STAFF RECOMMENDATION

2606 Barton Avenue

November 18, 2015

Application: Demolition—outbuilding and addition; New construction—addition and outbuilding; Setback determination

Figure 4 (left) is the 1957 Sanborn Map and Figure 5 (right) is the existing rear addition

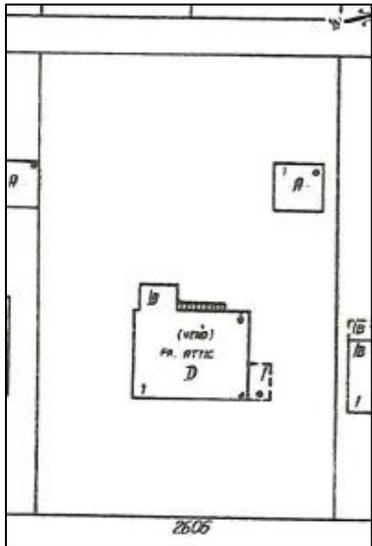
The date of construction for the addition that is to be demolished is unknown, but it does not seem to be on the 1957 Sanborn map (Figures 4 - 7). It is only minimally visible from the street, and its demolition will not affect the historic integrity of the main house or the larger historic neighborhood. Staff finds that the proposed demolition of the existing outbuilding and the addition meet Section III.B.2 for appropriate demolition and do not meet section III.B.1 for inappropriate demolition.

sheet title:
A-2 detached accessory floor plans

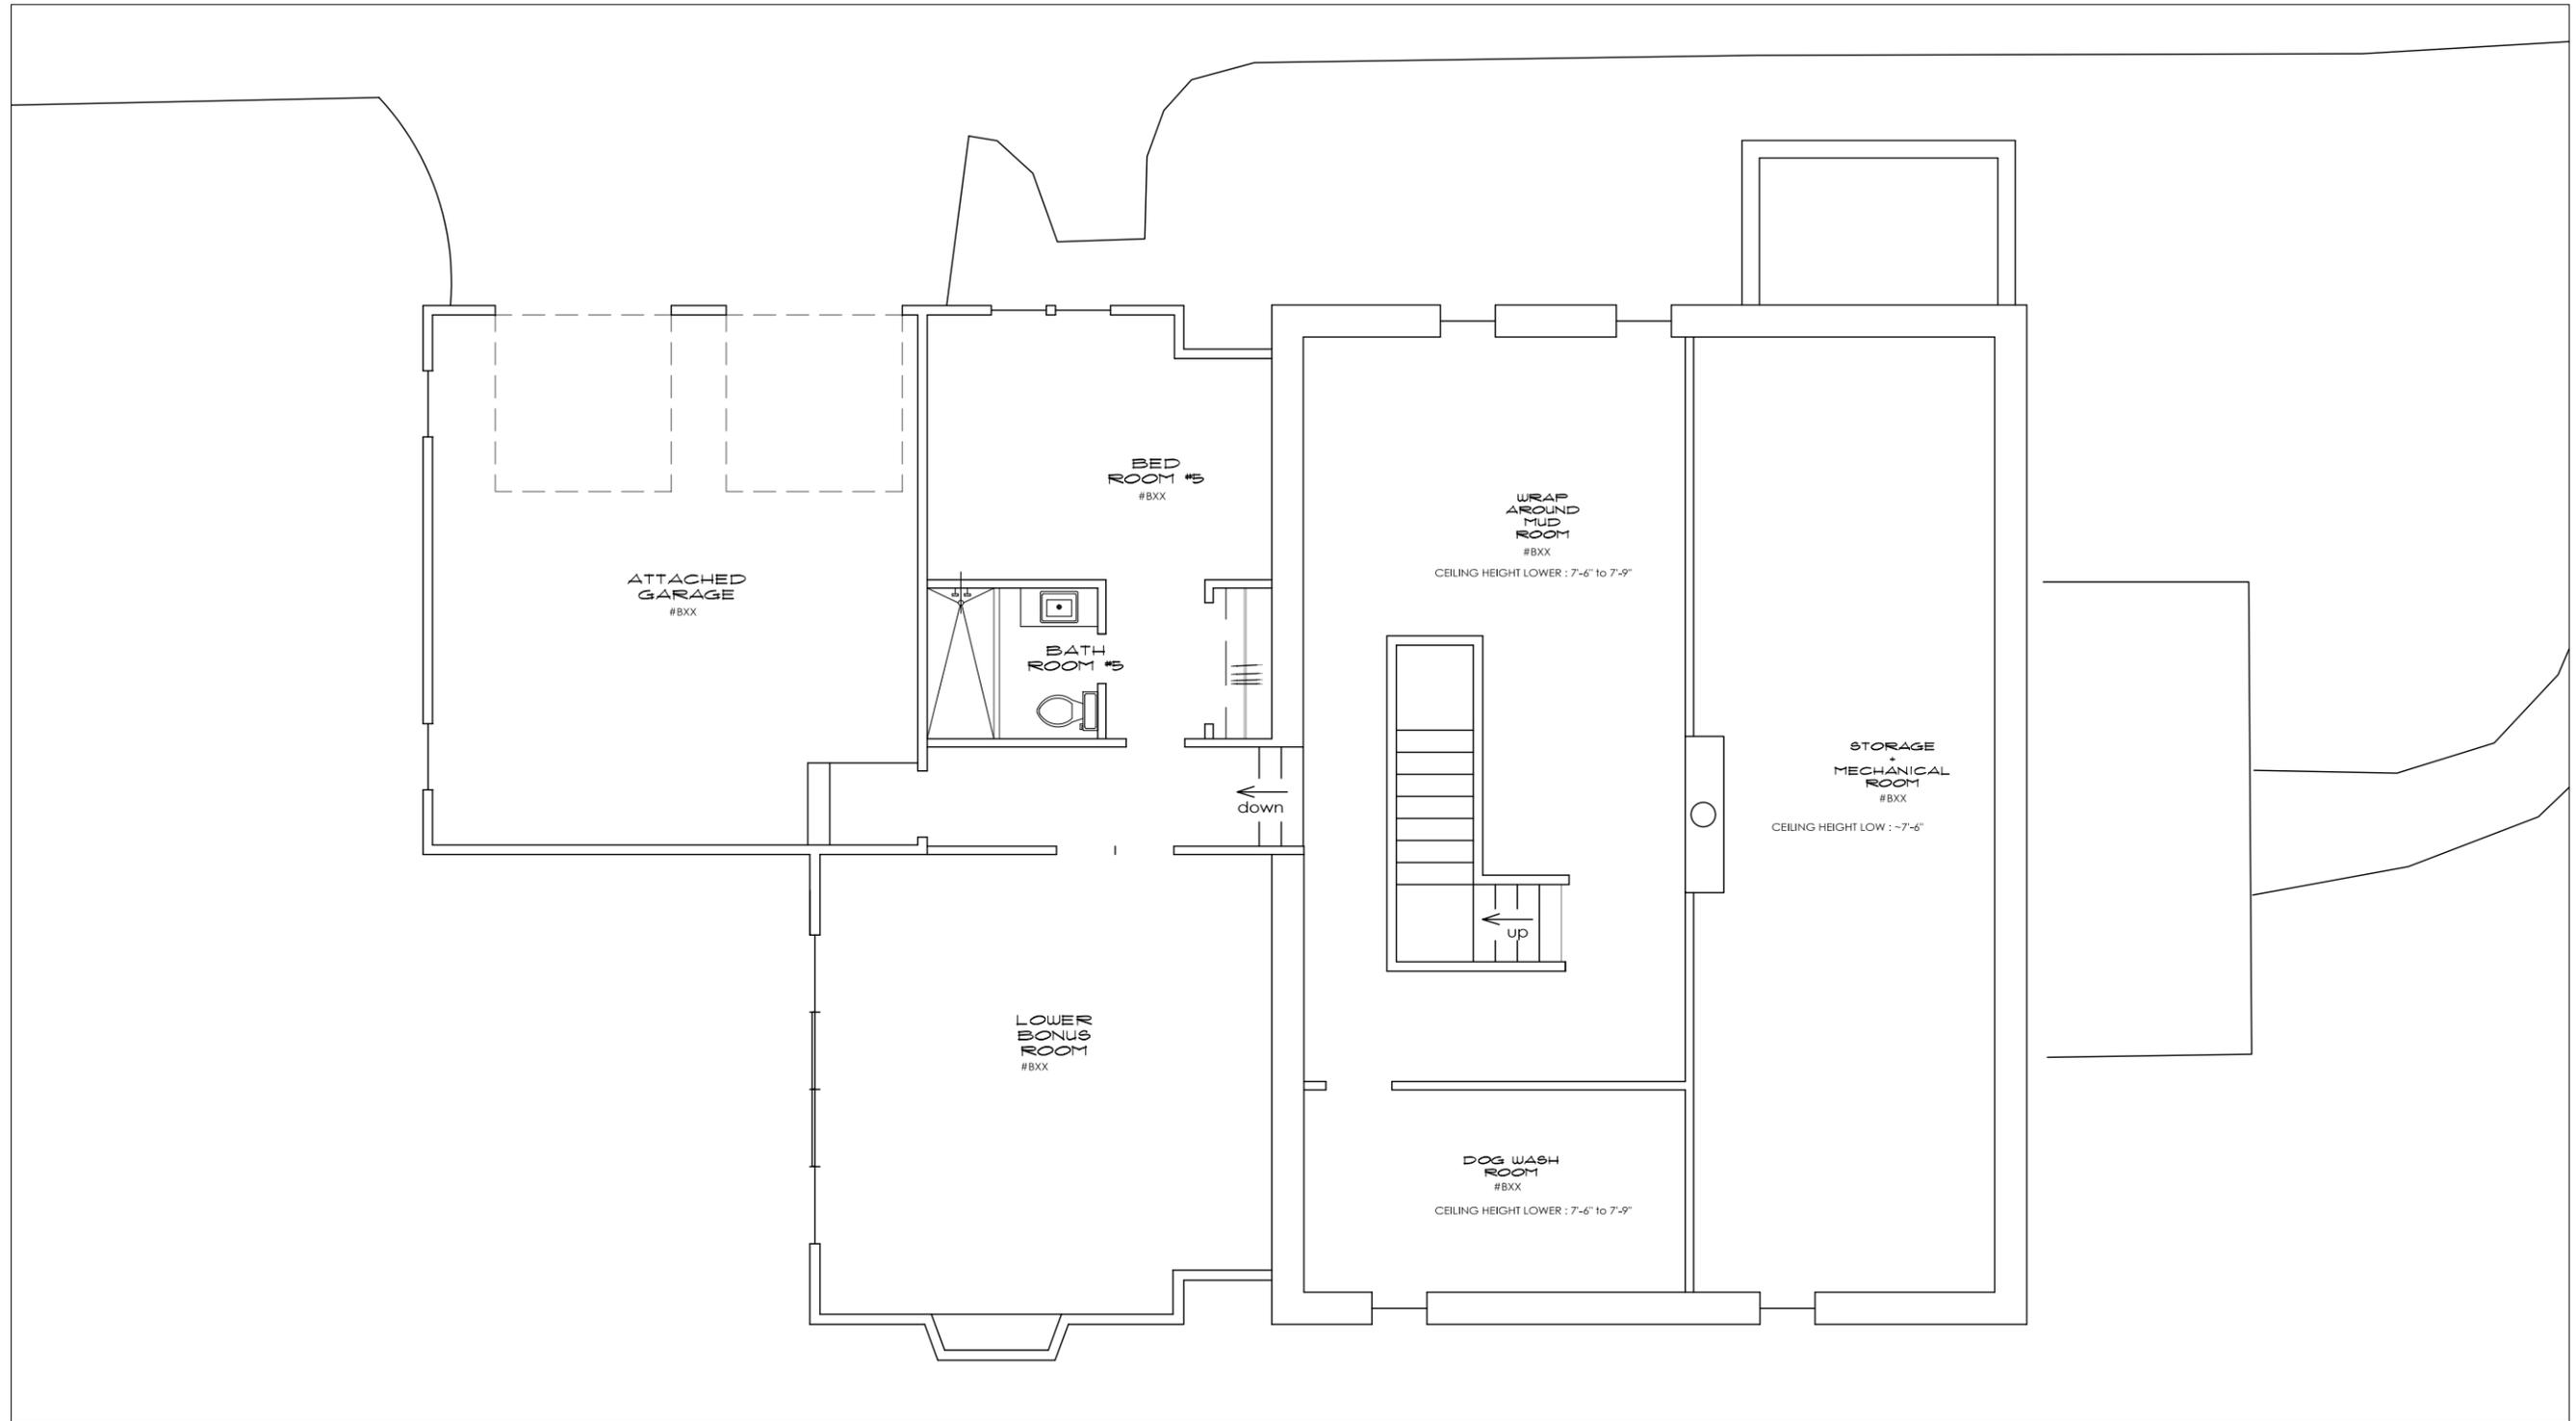
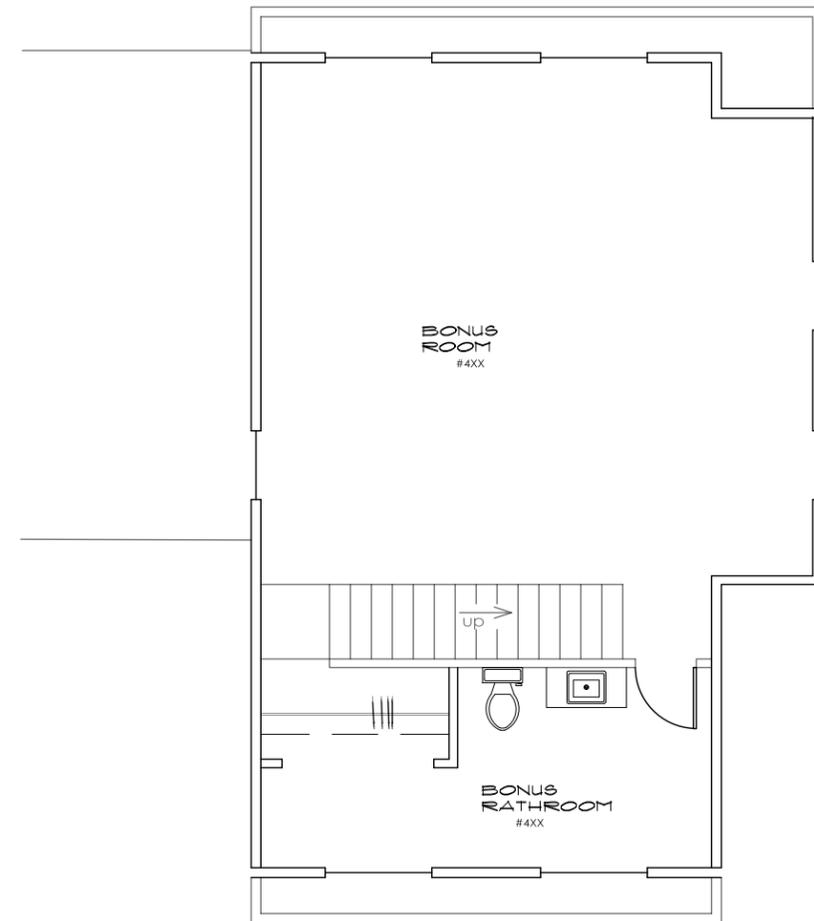
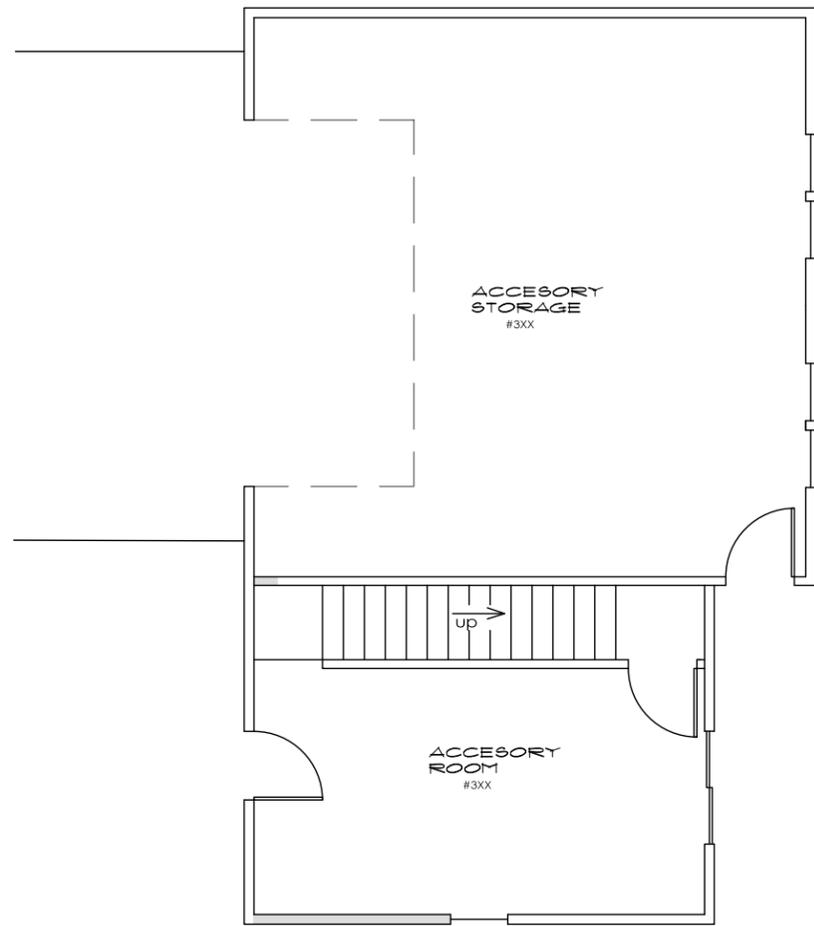
The applicant is also proposing to construct a detached outbuilding which cannot be used as a detached accessory dwelling unit (DADU) because the neighborhood is zoned for single family. See the attached "Outbuilding Worksheet" for a full analysis of the appropriateness of the outbuilding. Because the outbuilding will not be used as a DADU, the dormers that cover more than fifty percent (50%) of the roof plane are appropriate.

Because the lot is larger than ten thousand square feet (10,000 sq. ft.), the proposed footprint of nine hundred and forty square feet (940 sq. ft.) is appropriate. However, Base Zoning requires that outbuildings with footprints larger than seven hundred square feet (700 sq. ft.) be five feet (5') from the side property lines and twenty feet (20') from the rear property lines. The proposed outbuilding meets the side setbacks but does not meet the required twenty foot (20') rear setback; it is proposed to be ten feet (10') from the alley. Staff finds that the proposed rear setback determination is appropriate because historically, outbuildings were located close to the rear and side property lines, and the ten foot (10') rear setback allow for more space in between the outbuilding and the primary structure.
